**Spectra Energy Midstream Canada Partner Corporation, as general partner for Spectra Energy Midstream Canada L.P. (SEMC) Application for Approval to Reactivate the Pesh Creek Pipeline and Pesh Creek Loop (Pipelines) pursuant to section 45 of the National Energy Board Onshore Pipeline Regulations (Reactivation Application)**

**NEB File No.: OF-Fac-Gas-S383-2016-01**

**Response to Information Request No. 2**

**2.1 Coating condition and external corrosion**

Figure 2: Modified B31G calculation assuming failed coating on girth weld

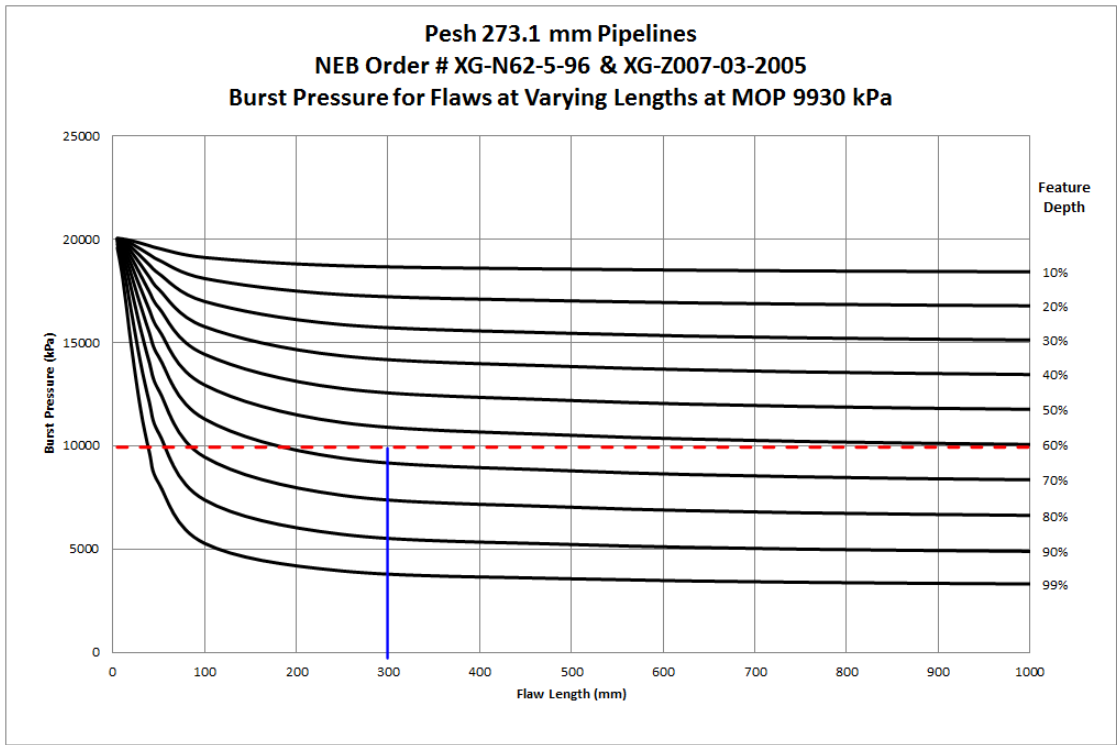
- a) Assessments demonstrating that the pipe coating is in satisfactory condition along its entire length; and
- b) Spectra's ILI program for the Pesh Creek Pipeline and Pesh Creek Loop following the proposed reactivation, considering that ILI has never been conducted in spite of the existence of launchers and receivers.

Of note, CNR has also evaluated the Pipelines for gross external wall loss. Based on typical girth-weld exposure areas, in the event that the girth-weld coating system has failed and is shielding the pipe from cathodic protection, the following Modified B31G assessment indicates that the pipeline would require ~65% wall loss over the entire (~300 mm) girth-weld area to cause rupture (see Figure 2). Based on this assessment, there is a low likelihood of failure due to pipeline rupture.
